STAFF REPORT: 12/9/2020 MEETING

ADDRESS: 290 EDMUND PLACE

HISTORIC DISTRICT: BRUSH PARK

SCOPE: ERECT A NEW BUILDING (REVISION TO PREVIOUSLY-APPROVED PROPOSAL)

290 Edmund Place (Building D-2), design which the Commission reviewed and denied at the November 2020 regular meeting.

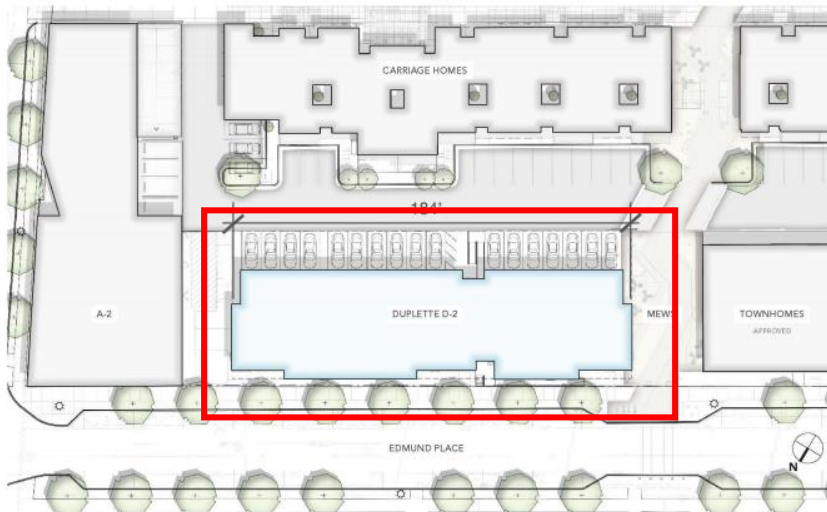
Specifically, the Commission noted that the original D-2 design approved in 2016 presented an aesthetic which was cohesive with the design of the new structures that were proposed for erection directly adjacent to the D-2/within the 200 and 300 block of Edmund Place. In re: to the revised design which was denied at the November 2020, the Commission noted issues with the following:

- **Massing:** The building should read more as multiple buildings with pass-throughs, reflecting the broken streetscape of the historical homes and serving as tradeoffs to the bookend buildings.
- **Materiality:** Material strategies should create more “softness” and “rhythm”.
- **Street Front:** The concrete base should contrast less with building body.
- **Openings:** The building openings should respond more to the openings on the adjacent Townhomes

BUILDING ELEVATION (Facing Edmund Place)

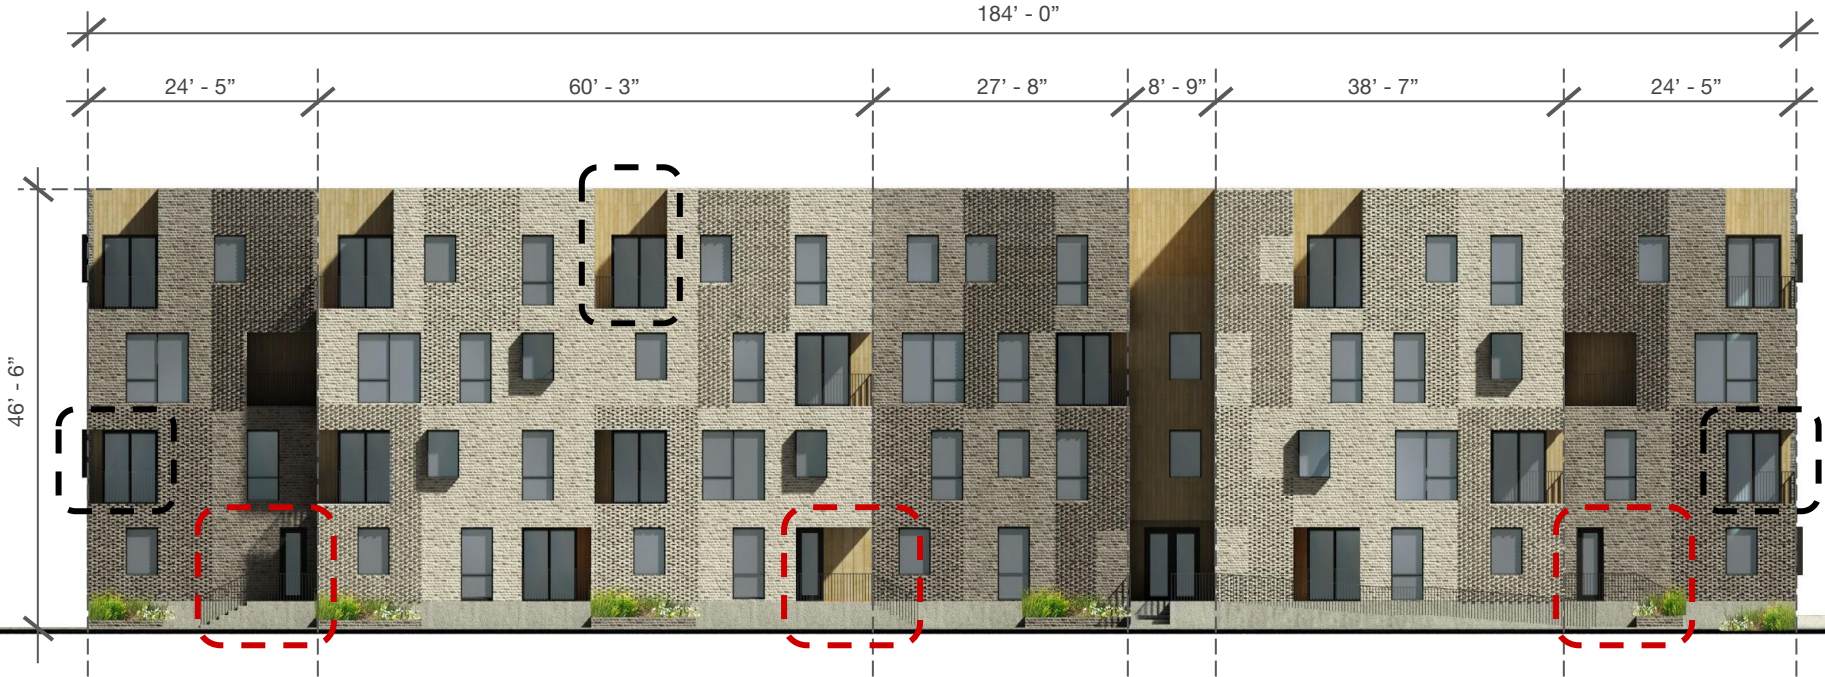
- Newly added balconies
- Newly added stoops and stair access

- ❑ **Massing:** A staggered setback and varied brick tones break down the massing into more vertically oriented proportions. Addresses *Brush Park Elements of Design* #2, #16, and #19.
- ❑ **Materiality:** A revised material palette, composition, and texture adds variety, softness, and scale. Addresses *Brush Park Elements of Design* #7, #8, and #9.
- ❑ **Street Front:** Ground floor stoops and landscaping engages the pedestrian scale along the street. Addresses *Brush Park Elements of Design* #6, #17, and #20.
- ❑ **Openings:** Windows, varied in size, bridge the two scales of the Townhomes and the LOHA bookend buildings. Addresses *Brush Park Elements of Design* #3 and #4.
